ORDINANCE NO. 1661

**AN ORDINANCE AMENDING ORDINANCE NO. 1253
KNOWN AS THE ZONING ORDINANCE**

Zoning Change: M-1 to PUD

Case: ZC 19.12 Summer Lane PUD

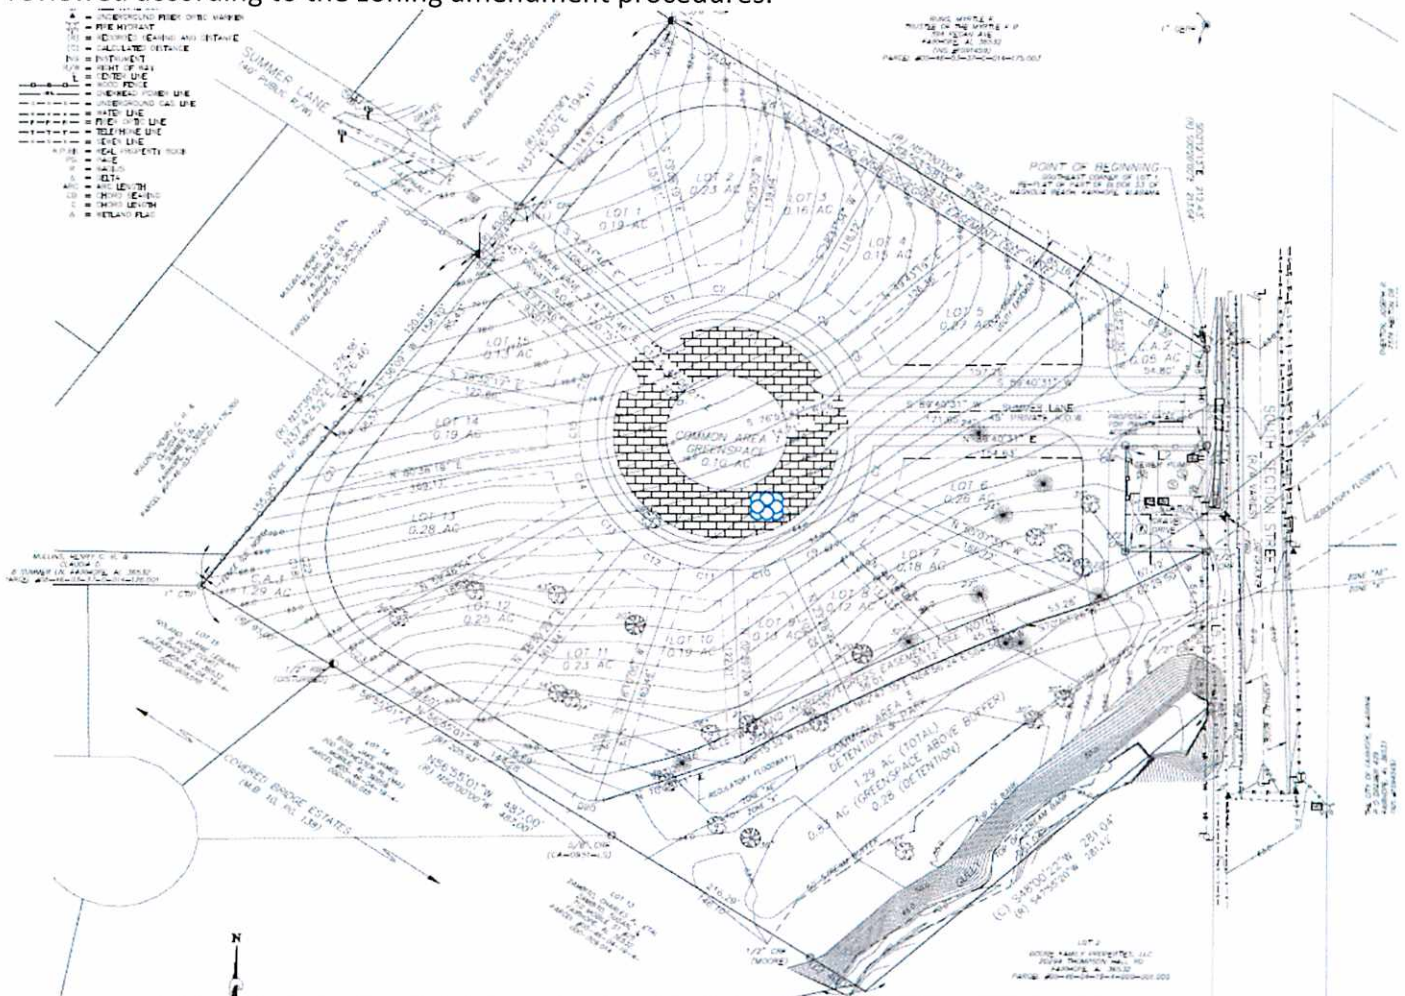
The proposed PUD characterizes the intent of the PUD district by proposing an innovative design that is not your typical lot and block subdivision that could not be done in any other zoning district. The proposed design is to allow for a community to be developed near the downtown area that has very minimal maintenance and promotes a pedestrian friendly environment. The applicant goes into detail in the attached narrative.

The design for this community also incorporates some aspects that would require multiple waivers from the subdivision regulations to be approved by the Planning Commission during the subdivision process. They desire to have the entrance from Section Street gated, to have private roads, to have non-paved roads. The private non paved roads then require a waiver to create lots not on paved publicly maintained road. The 15% green space requirement based on the net density is met but only by counting the 16' alley as one continuous driveway and not a private ROW. During the subdivision process this could require a waiver as well.

There is an alleged mapping error on the FEMA Flood Maps and the applicant is on the process of requesting a Letter of Map Amendment (LOMA) through FEMA. A flood way is mapped north of where the topographic survey shows the gulley being located. Staff does not disagree that there may be a possible error but, because of this the site had to be designed around where the floodway is mapped. If this PUD is approved and the LOMA is granted by FEMA a possible PUD amendment could be done to increase the lot sizes and other small aspects of the design.

Although staff approves of the design and concept of this project staff can not recommend approval of a PUD that would require the Planning Commission to also approve the various waivers that would be associated with the subdivision application.

Staff recommends Case: ZC 19.12 Summer Lane PUD be **APPROVED** without any waivers.
